HRT-5H NEW MUFFIN SETTINGS PROGRAMMING INSTRUCTIONS

AFFECTED PRODUCTS: HRT-5H Toasters

This document describes how to change the settings on the HRT-5H toaster for the new McDonald's Muffin. Please contact A.J. Antunes & Co. Technical Service at 1-877-392-7854 with any questions or concerns regarding these instructions.

Figure 2. HRT-5H Control Panel

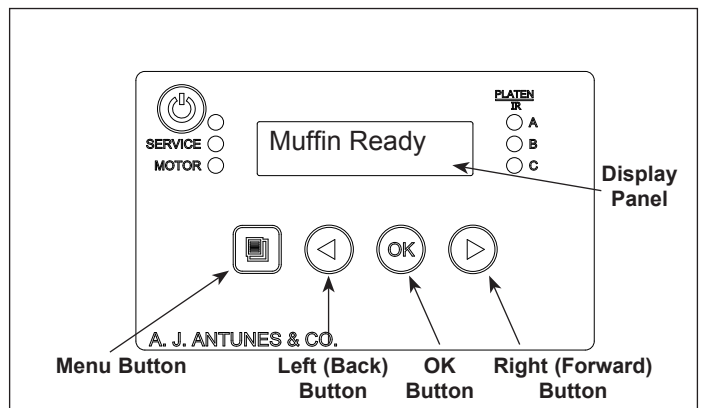
1. While in "Muffin Ready", press ◀ or ▶ to adjust the Light/Dark Adjustment value to the center setting.
2. While in "Muffin Wait" or "Muffin Ready", press and hold the **MENU** button (Figure 2) until the control panel displays "Heater A" The display shows the setpoint, operating current, and SSR Duty cycle.

3. Press the **OK** button. Then use the ◀ and ▶ buttons to change the Heater A value to 65%. Press **OK** again to save the change.
4. Press ▶ (Figure 2) to scroll to the Heater B setting. Press **OK**. Then use the ◀ and ▶ buttons to change the Heater A value to 65%. Press **OK** again to save the change.

Value	Default Setting
Heater A & B	65%*
Heater C	0 %*
Muffin Toast Color	750*
Bagel Toast Color	500*
